## *Installation Bulletin*

**BULLETIN NO: 455**

**APPLICABLE TO:** MDHS MD900 equipped with Flexcomm II per STC SR00240WI-D (VFR Utility Avionics Installation) or STC SR00436WI-D (KFC 900 AFCS and IFR Avionics Installation.)

**SUBJECT:** Flexcomm II Coax Cable Modification

Figure 1

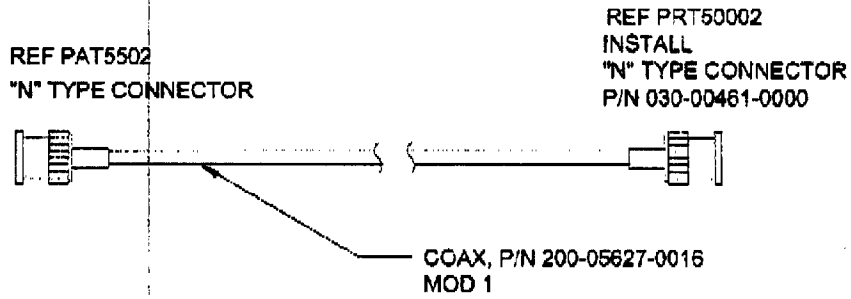
1. Disconnect and remove the following coax cables from the aircraft:  
(These coax cables are routed from the RT-5000 to the AT-550 Antenna.)
  - 200-05627-0016 (C5000-200A)
  - 200-05627-0017 (C5000-201A)
2. Remove the existing TNC connector (PRT50002) from coax cable P/N 200-05627-0016. Replace it with N connector P/N 030-00461-0000 as shown in Figure 1.

Figure 2

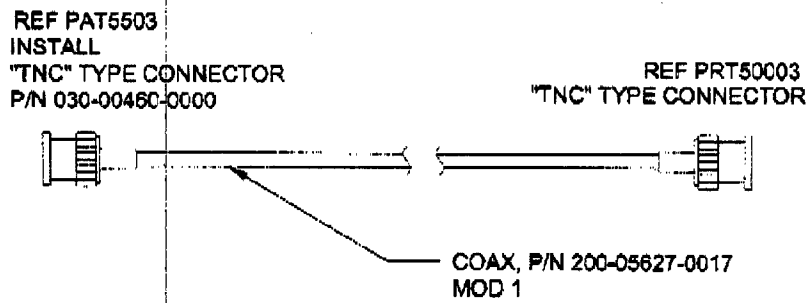
3. Remove the existing N connector (PRT50003) from coax cable P/N 200-05627-0017. Replace it with TNC connector P/N 030-00460-0000 as shown in Figure 2.
4. Mark each coax cable as follows: MOD 1
5. Reinstall the modified coax cables, and connect them as shown in Figure 3.
